GRADING, EROSION AND SEDIMENT CONTROL PLANS
CHICK-FIL-A POWERS & PALMER

GRADING, EROSION, AND SEDIMENT CONTROL PLANS

CHICK-FIL-A
POWERS & PALMER PARK

PCD FILE # PPR2521 1 OF 14

CONSULTANT PROJECT #
PRINTED FOR
DATE 10/23/2026
DRAWN BY BRJ
SHEET GRADING PLAN
SHEET NUMBER C2.0

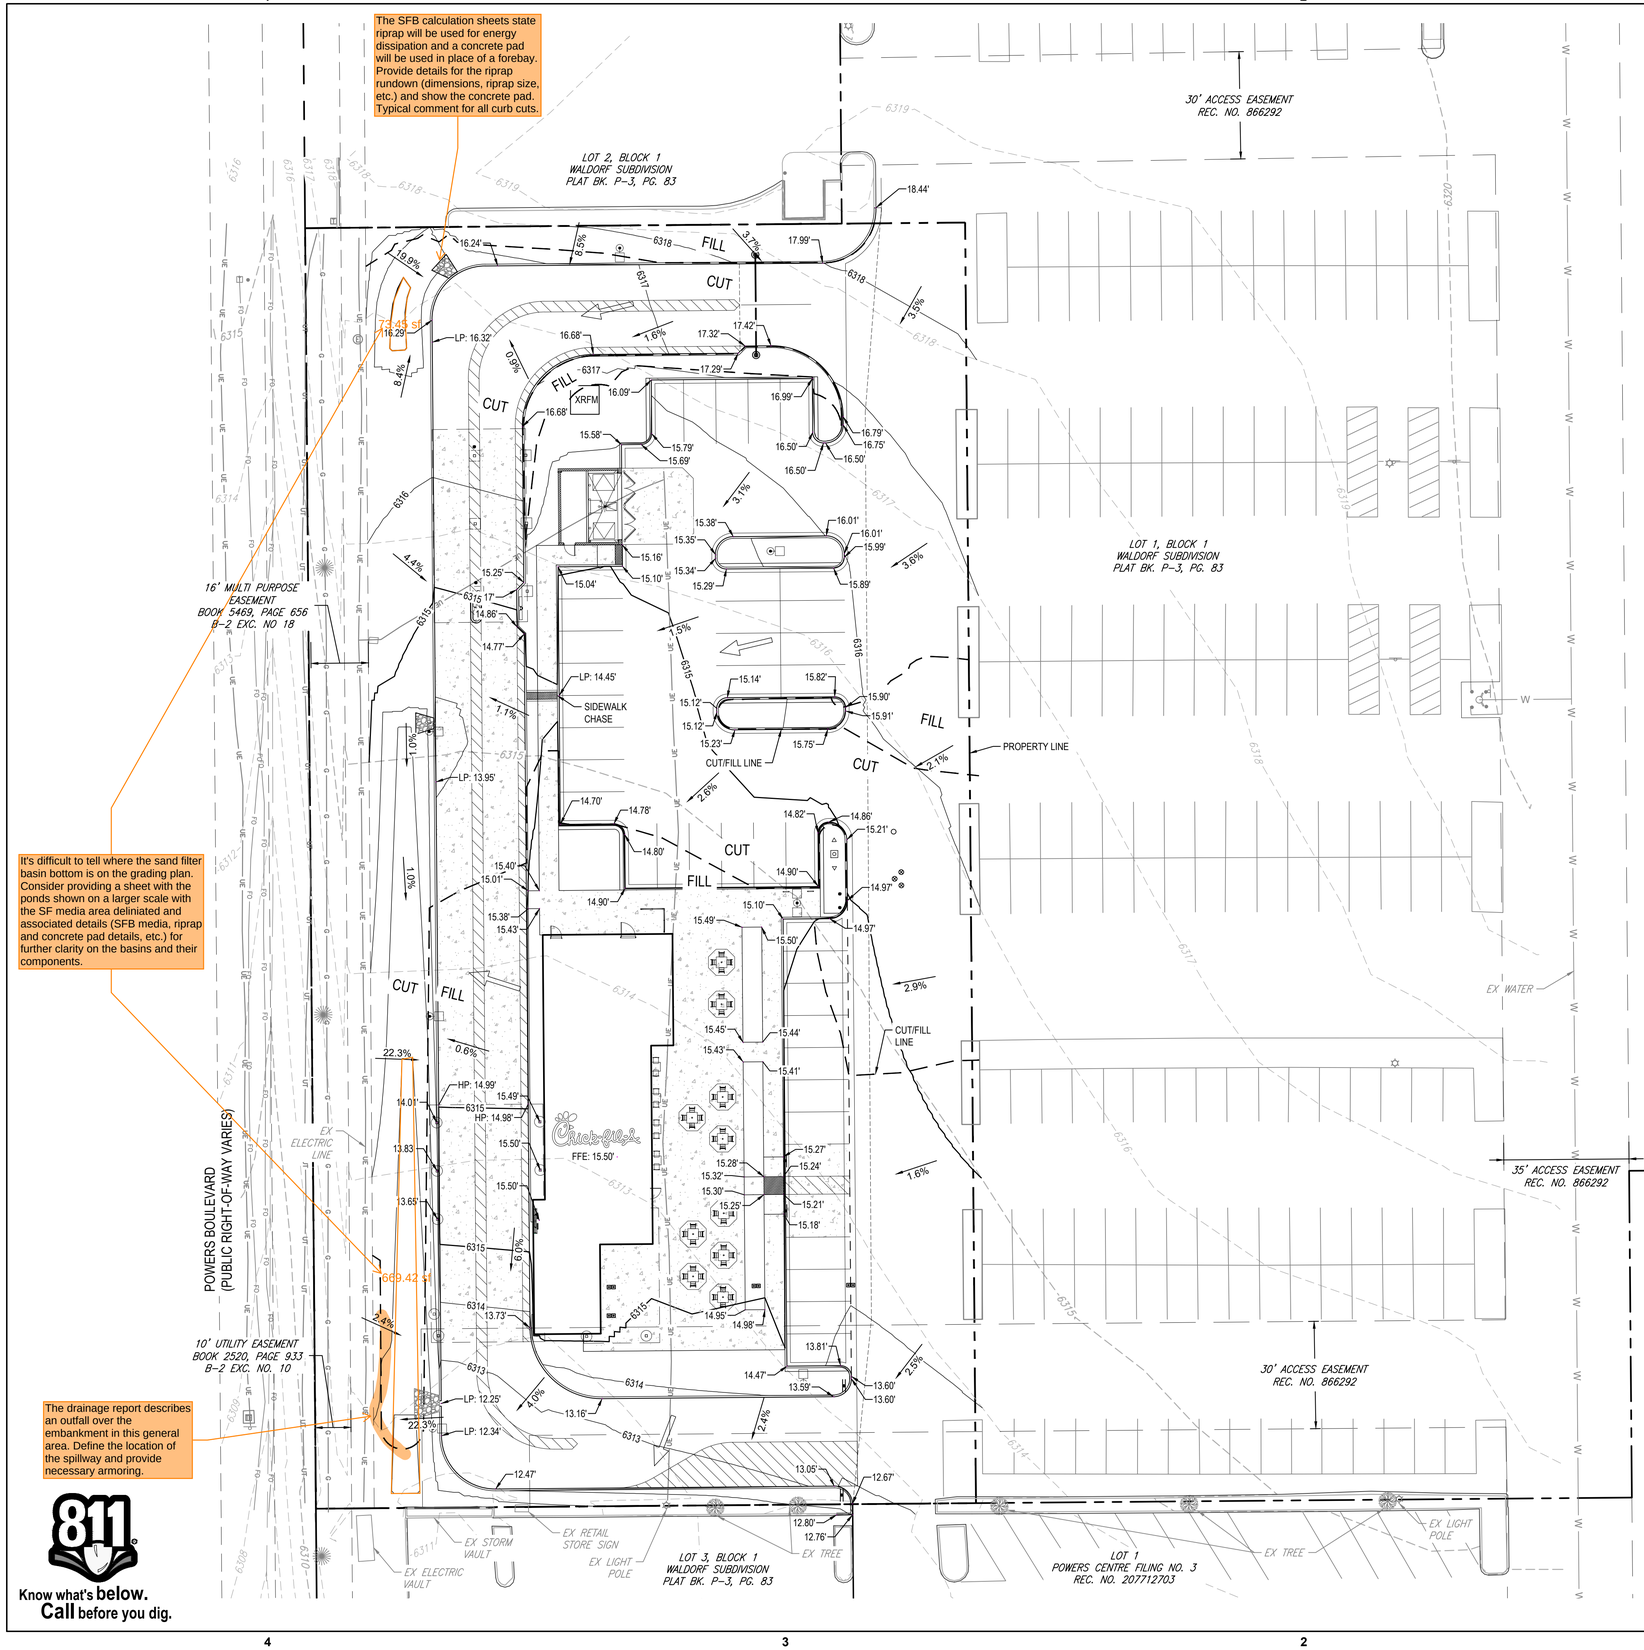
The SFB calculation sheets state riprap will be used for energy dissipation and a concrete pad will be used in place of a forebay. Provide details for the riprap rundown (dimensions, riprap size, etc.) and show the concrete pad. Typical comment for all curb cuts.

It's difficult to tell where the sand filter basin bottom is on the grading plan. Consider providing a sheet with the ponds shown on a larger scale with the SF media area deliniated and associated details (SFB media, riprap and concrete pad details, etc.) for further clarity on the basins and their components.

The drainage report describes an outfall over the embankment in this general area. Define the location of the spillway and provide necessary armoring.

CONSULTANT PROJECT #
PRINTED FOR
DATE 10/23/2026
DRAWN BY BRJ
SHEET EROSION CONTROL DETAILS
SHEET NUMBER C4.0

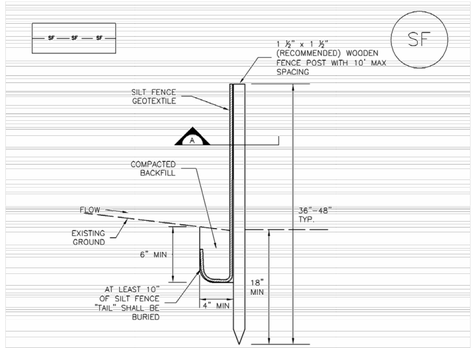
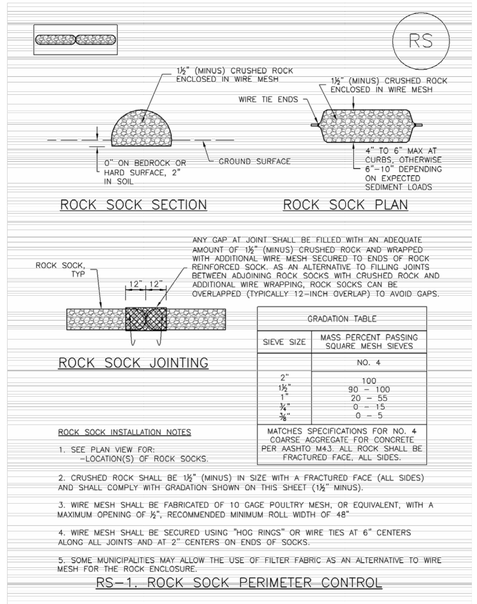
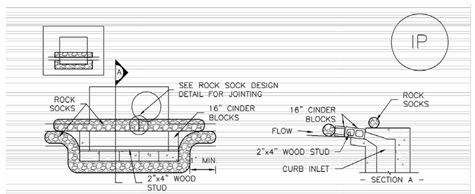
Need Standard Design detail for Sand Filter Basin
